Access Compliance Report

Public Rights-of-Way

(Curb Ramps)

Intersection ID: 48584	Main Street: TREEFROG_CT	Cross Street: WATERLILY_LN	Location:	N
ADA ID: 64DE2874D5C6	Ramp Type: PerpDiag	Initial Pass/Fail: Fail	Overall Compliance: No	Severity Score: 21.25
Codes/Mitigation Info/Possible Solution		Field Measurements/Component Compliance

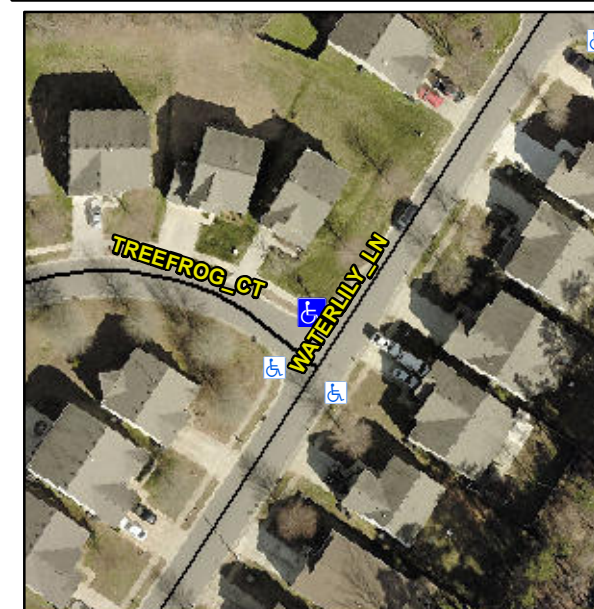
Not Found, R304.5.1, R304.2.2

Compliance	Description	Data	Compliance	Description	Data
N/A	Ramp Length (in)	46.0	No	Ramp Slope (%)	9.0
No	Ramp Width (in)	40.0	Yes	Ramp XSlope (%)	0.6
N/A	Flare Type LT	N/A	N/A	Flare Type RT	N/A
N/A	Flare Slope LT (%)	N/A	N/A	Flare Slope RT (%)	N/A
N/A	Flare Traversable LT?	N/A	N/A	Flare Traversable RT?	N/A
N/A	Landing Length (in)	N/A	N/A	DWS Provided?	N/A
N/A	Landing Width (in)	N/A	N/A	DWS Contrast?	N/A
N/A	Landing Slope (%)	N/A	N/A	DWS Length (in)	N/A
N/A	Landing X Slope (%)	N/A	N/A	DWS Full Width?	N/A
N/A	Landing Curb? (Y/N)	N/A	N/A	DWS Offset (in)	N/A
N/A	Shared Landing?	N/A			
N/A	Gutter Ponding?	N/A	N/A	Gutter Slope (%)	N/A
N/A	Gutter Lip Ht (in)	0.75	N/A	Gutter X Slope (%)	N/A
N/A	Painted X Walk1?	No	N/A	Painted X Walk2?	No
	X Walk 1 Direction	To SW		X Walk 2 Direction	To SE
N/A	X Walk 1 Width (in)	N/A	N/A	X Walk 2 Width (in)	N/A
	X Walk 1 Slope (%)	5.9		X Walk 2 Slope (%)	2.6
	X Walk 1 X Slope (%)	1.9		X Walk 2 X Slope (%)	4.0

Remove & Replace Curb Ramp With Two New Directional Ramps or Equivalent.
